Sept. 28, 2017

ADMINISTRATIVE HEARING

STAFF REPORT

PROJECT: Elizabeth Subdivision, PDP160046

② Upper Level - Theoretical
1/8" = 1'-0"

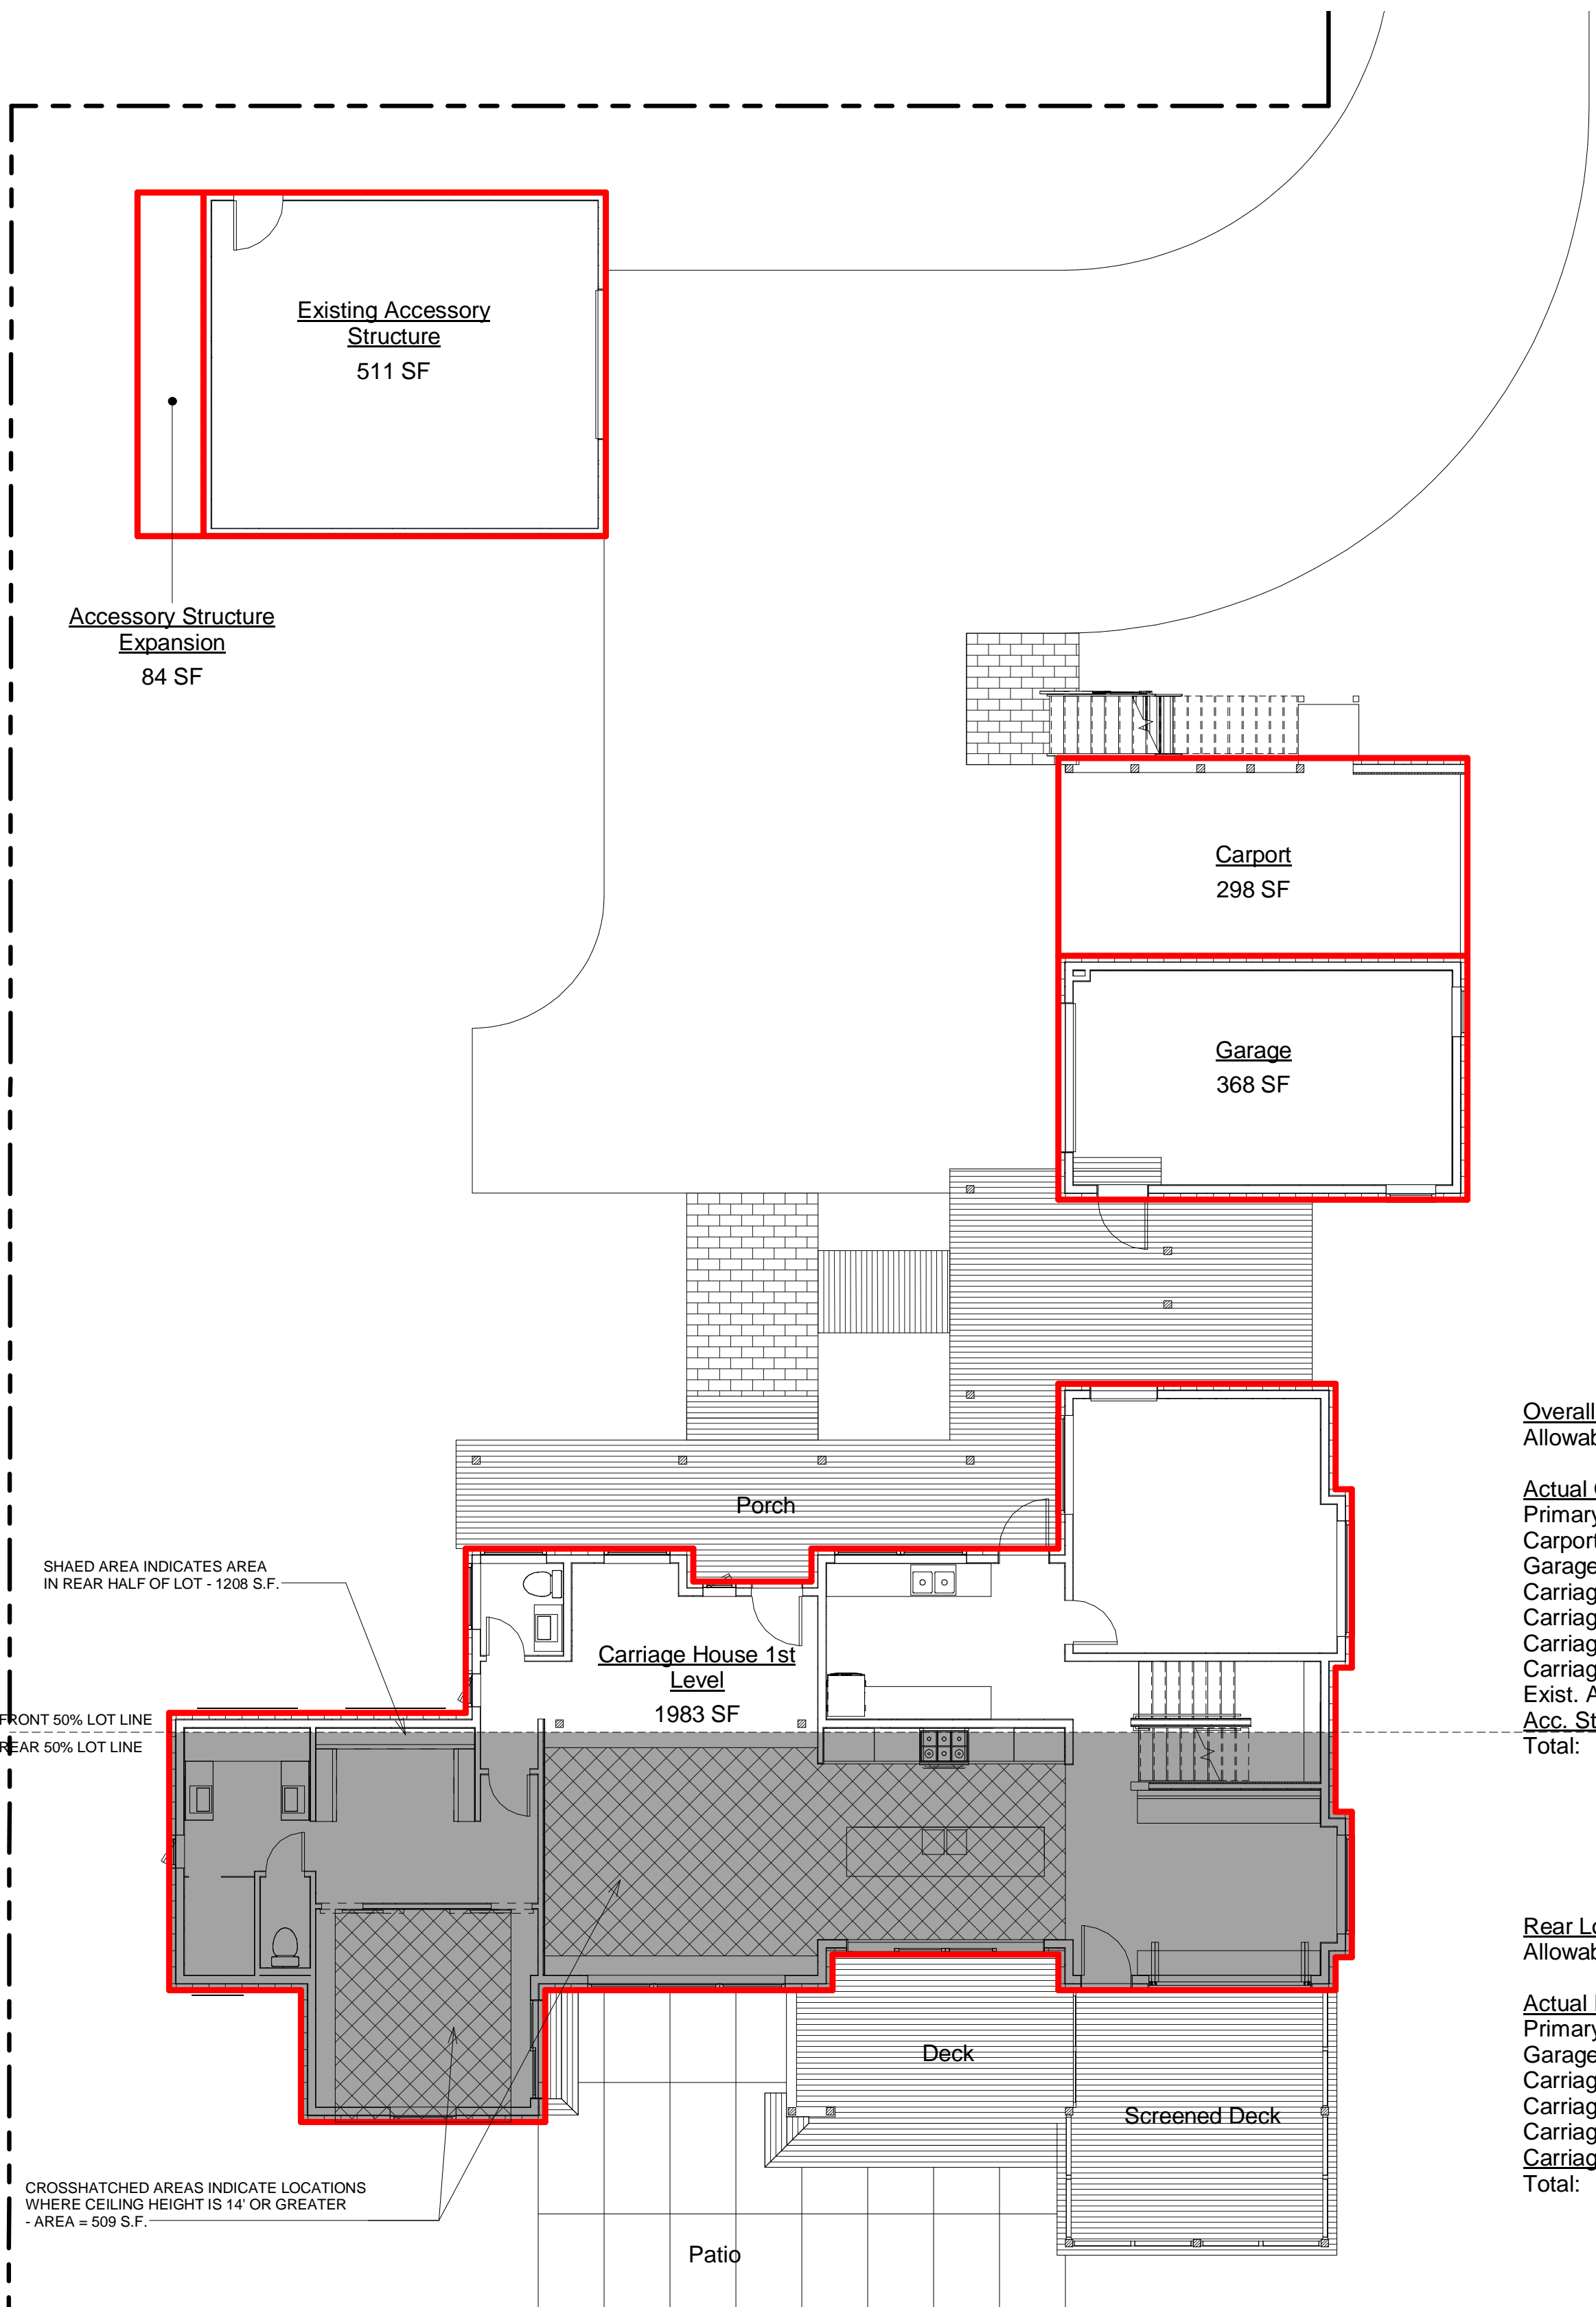
- *Flagpole creating skewed mid lot line: If the mid lot line did have to take into account the flagpole portion of the lot then the mid lot line would move further south. As the plan is shown with the carriage house in the rear and primary residence in front this would result in only 140 sf over the maximum allowed amount. Please see attached Floor Area Diagram – Theoretical A-3.*

Staff finds that the request for a Modification of Standard to section 4.7(D)(3) is justified by the applicable standards in 2.8.2(H)(1).
